SPACE VILLAGE FILING No. 3 PRELIMINARY PLAN

#0692 - EL PASO COUNTY, CO
6809 SPACE VILLAGE AVENUE
PRELIMINARY PLAN

Markup Summary

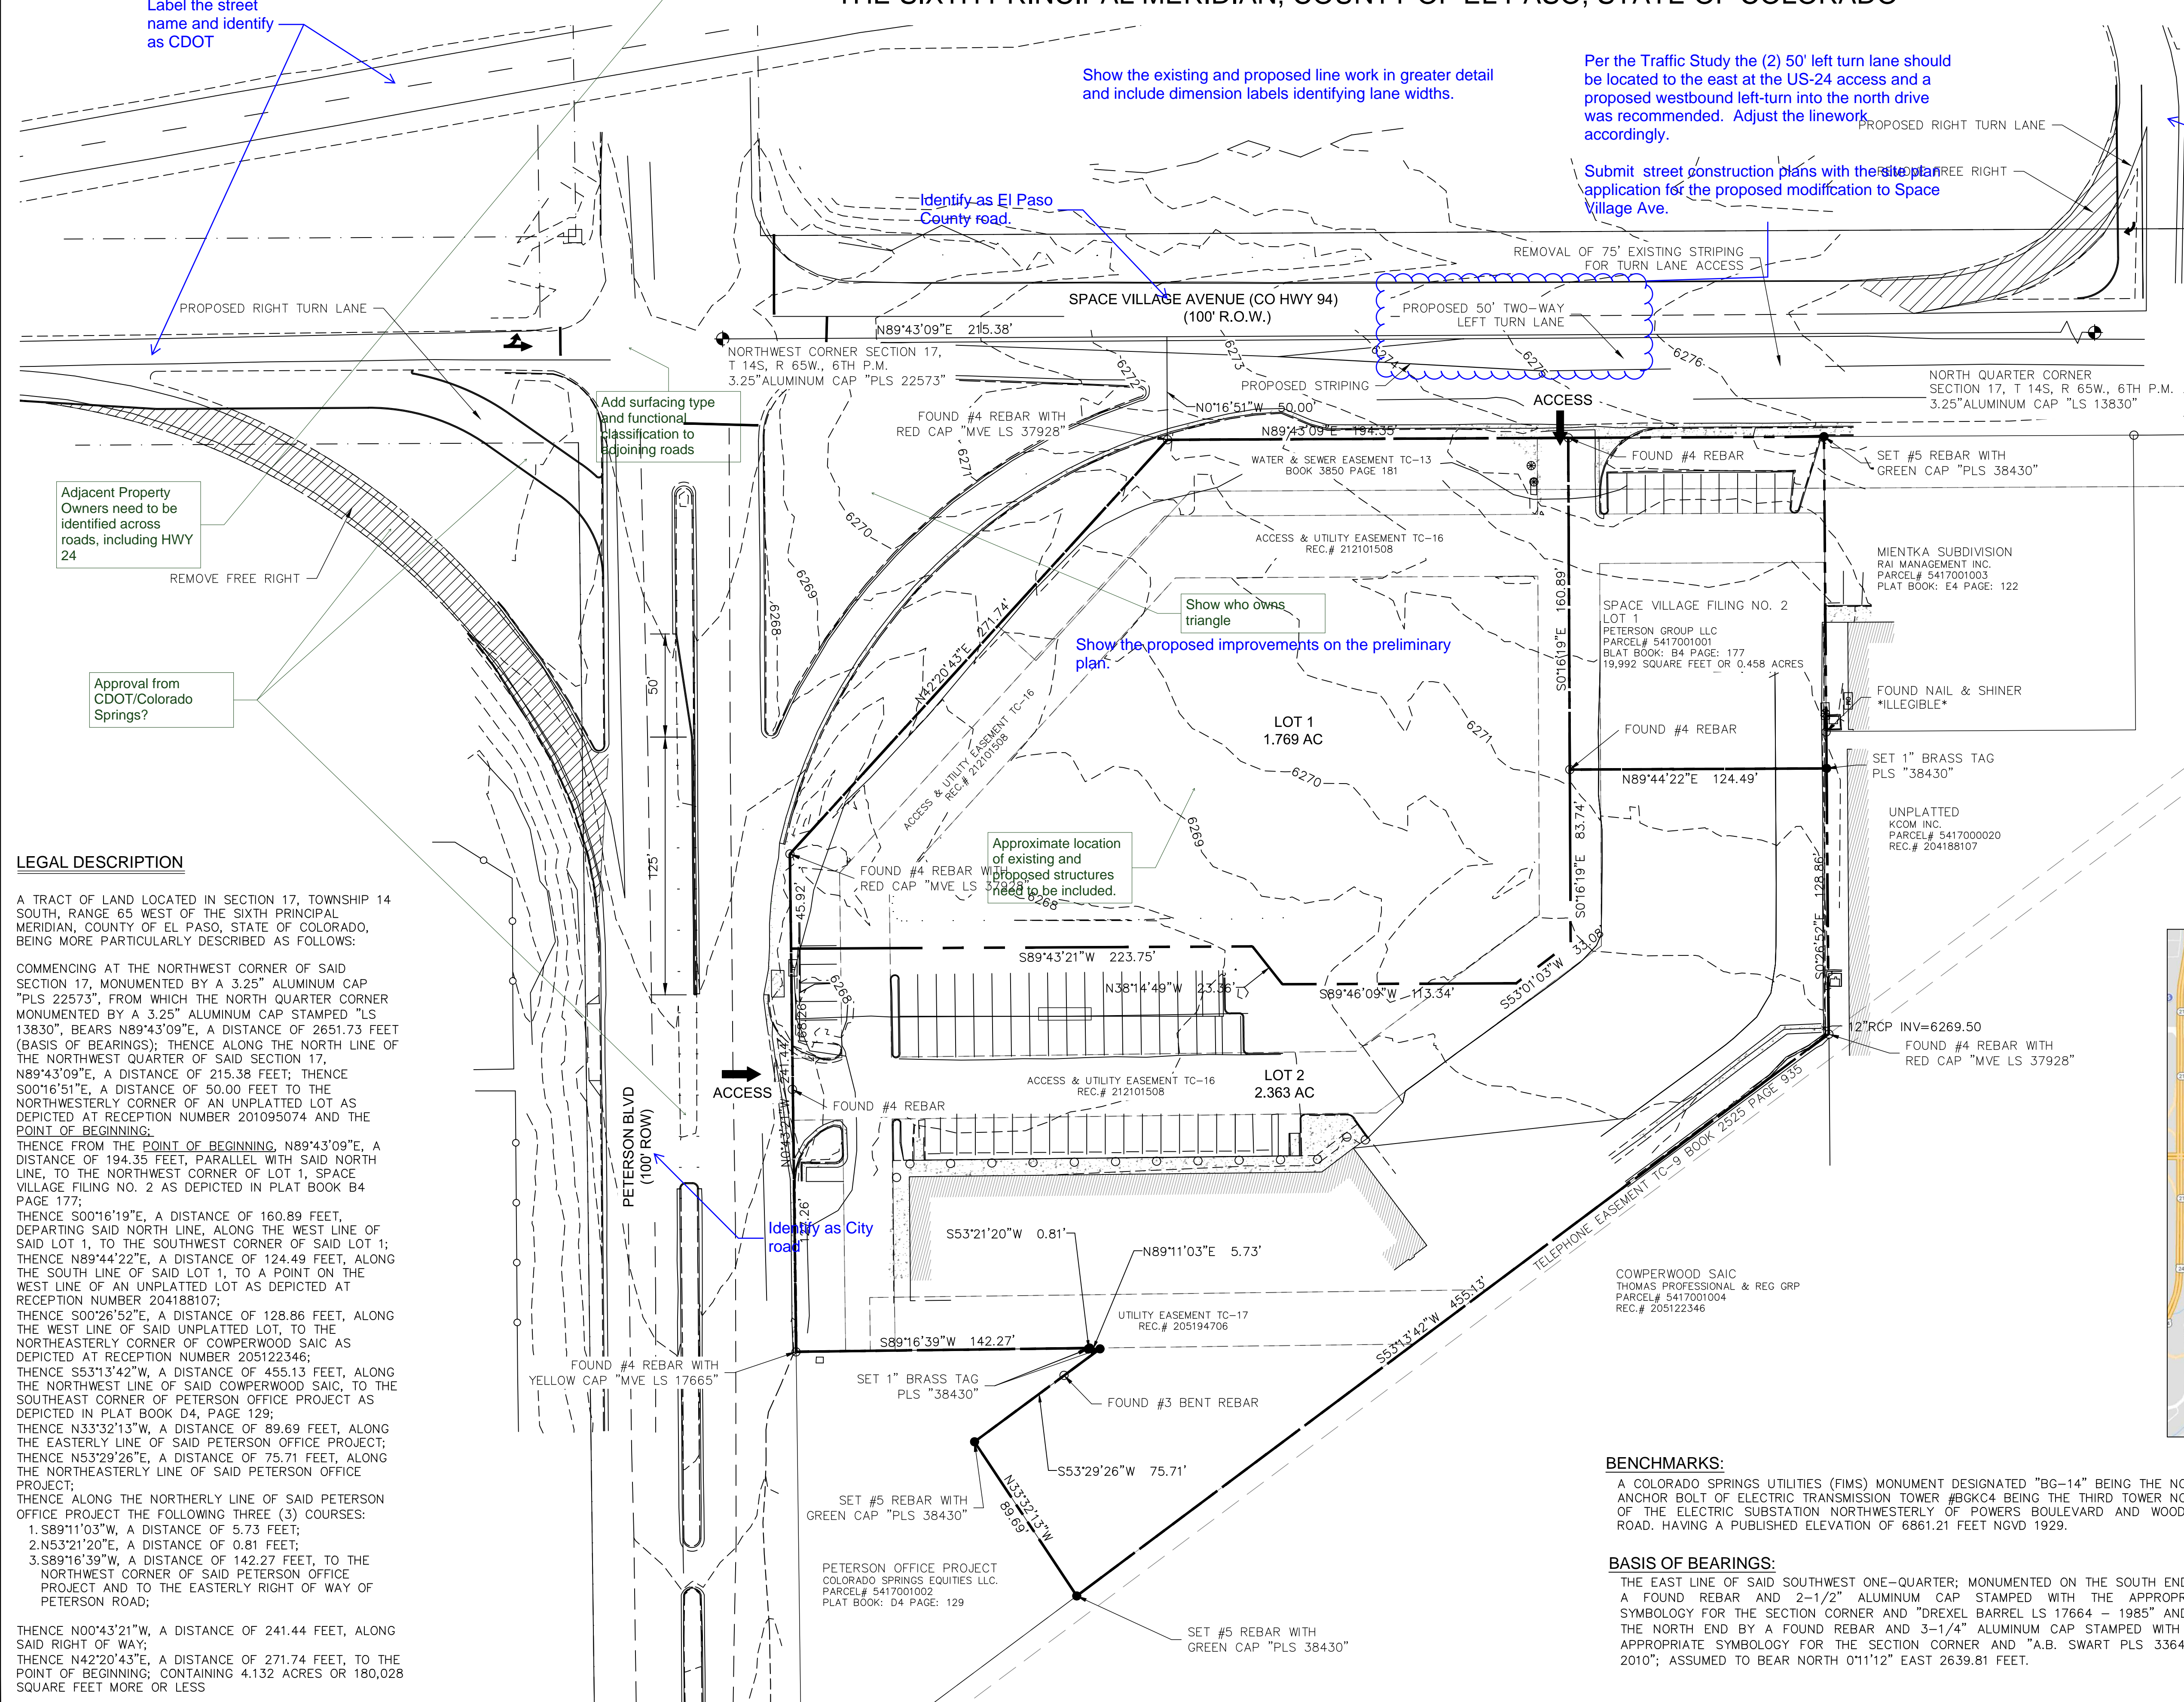
Label the street name and identify as CDOT

Show the existing and proposed line work in greater detail and include dimension labels identifying lane widths.

Per the Traffic Study the (2) 50' left turn lane should be located to the east at the US-24 access and a proposed westbound left-turn into the north drive was recommended. Adjust the linework accordingly.

Label the street and identify as CDOT

Proposed improvements to City or County streets must be approved by these jurisdictions.

Identify as El Paso County road.

Submit street construction plans with the site plan application for the proposed modification to Space Village Ave.

Show the proposed improvements on the preliminary plan.

Approximate location of existing and proposed structures need to be included.

Adjacent Property Owners need to be identified across roads, including HWY 24

Approval from CDOT/Colorado Springs?

Show who owns triangle

Add surfacing type and functional classification to adjoining roads
